UNITED STATES PATENT AND TRADEMARK OFFICE

APPLICATION NO.	FILING DATE	FIRST NAMED INVENTOR	ATTORNEY DOCKET NO.	CONFIRMATION NO.
10/669,576	09/24/2003	Dieter Hochrainer	I/1401	6795

Office Action Summary

DETAILED ACTION

FIG. 4A

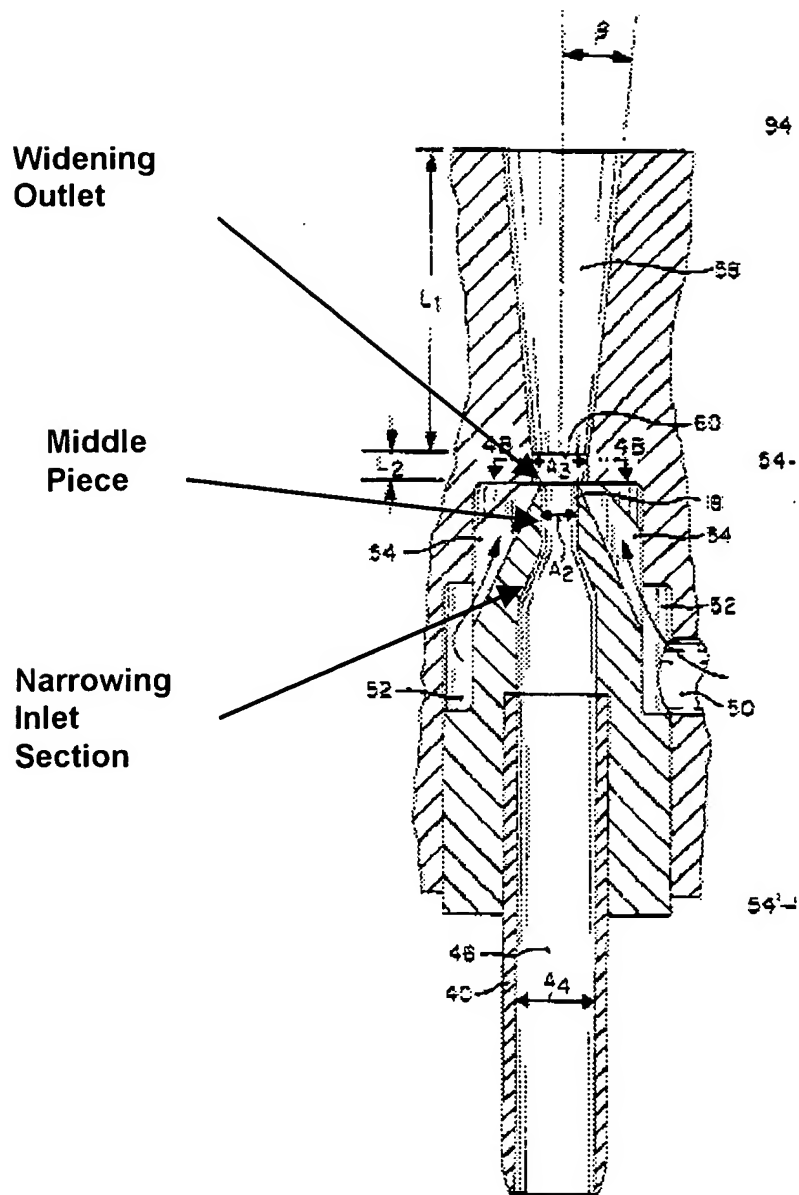
- with mouthpiece (32) for dispersing pharmaceutical drug formulations,
- having an auxiliary energy source (338, 390) in the form of a pressure medium system,
- with a device (342) for provisioning of a powder formulation, whereby upon activation of the pressure medium system (338) a gaseous pressure medium released by the pressure medium system forms with the powder formulation an aerosol in such a way that the powder particles are present in dispersed form within the gaseous pressure medium, characterized in that provided in the inhaler is a Laval nozzle (14; because a laval nozzle is convergent-divergent nozzle (i.e., venturi-like), the nozzle of Smith is readable upon a Laval nozzle) through which the aerosol flows before leaving the inhaler (Figs. 1, 2).

Applicant's arguments filed 10/05/05 have been fully considered but they are not persuasive. Applicant argues that Smith does not disclose a Laval nozzle, however the examiner disagrees because a Laval nozzle is convergent-divergent nozzle (i.e., venturi-like), the nozzle of Smith is readable upon a Laval nozzle. Applicant has not provided any structural differences that would be readable over the nozzle of Smith. Applicant argues the "...in a Laval nozzle, gas is accelerated by the length-width geometry of the nozzle..." however there is no such claim language presented in the amended claims.
